Re: Oconee Nuclear Station
Docket Nos. 50-269-270, -287

In response to your letter of January 21, 1974, please find attached a description and safety evaluation of modifications of the Oconee Nuclear Station 230 KV switchyard breaker failure relay circuitry.

DUKE POWER COMPANY
OCONEE NUCLEAR STATION
SAFETY EVALUATION
MODIFICATIONS TO THE 230 kV SWITCHYARD

Development OCONEE NUCLEAR STATION See Dwg. _____ File No. _____
Subject PROPOSED BREAKER FAILURE RELAY DESIGN Sheet No. 1 of 1
By _____ Date 4/23/74

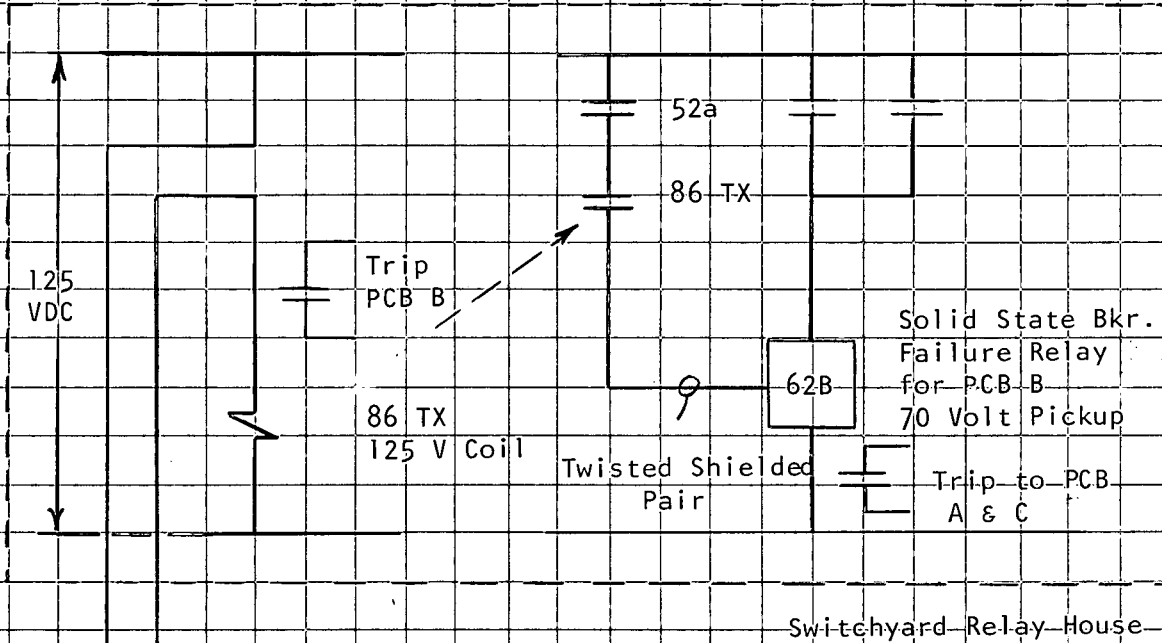
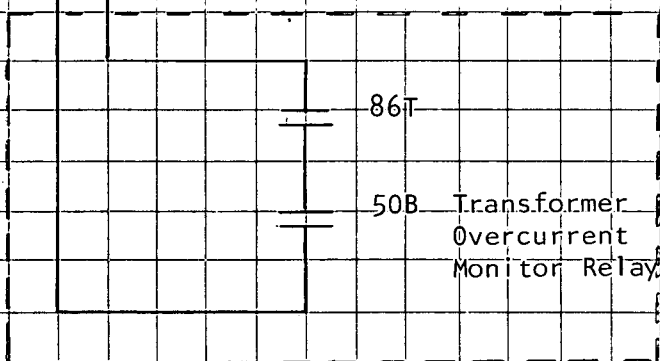
The following revisions to the affected circuit breaker failure relay circuits will be made to prevent actuation by spurious induced signals:

- (1) The five transformer lockout relay contact circuits from station to switchyard will be run in separate cables.
- (2) Additional ground cables will be installed in trenches between the station and the switchyard for increased electrostatic shielding.
- (3) Interposing relays with 125V DC coils will be installed in these circuits in the switchyard relay house.
- (4) Connecting circuitry from interposing relays to breaker failure relays will be by shielded twisted pair cable.
- (5) The pickup setpoint of the breaker failure relays will be increased from the present value of 15 volts to over 70 volts.
- (6) Overcurrent monitor relays will be installed to monitor the startup transformers for low side faults, and to supervise the interposing relay circuit.

The separation of the five transformer lockout contact circuits into five individual cables will prevent any induced currents in one cable from affecting more than one breaker failure relay initiating circuit. The additional ground cables installed in the trenches between the station and the switchyard will

provide increased electrostatic shielding and will protect the cables from external influences. The installation of the interposing relays with 125V DC coils in the circuit requires that any induced currents produce a voltage of such magnitude that its probability of occurrence is negligible. In the event that such an induced current did occur, it could not operate the interposing relay in the startup transformer lockout circuits unless the transformer overcurrent monitor relay, which supervises the circuit, had operated. In addition, contacts, from the interposing relay will be used to trip the associated circuit breakers. Since this circuit is supervised by PCB breaker auxiliary contacts, this precludes misoperation of the interposing relay which could, heretofore, initiate a false breaker failure signal. To preclude operation of the breaker failure relay by induced current in the circuit from the interposing relay, shielded twisted pair cable is utilized, and the breaker failure relay pick-up setpoint will be increased to a value of approximately 70 volts.
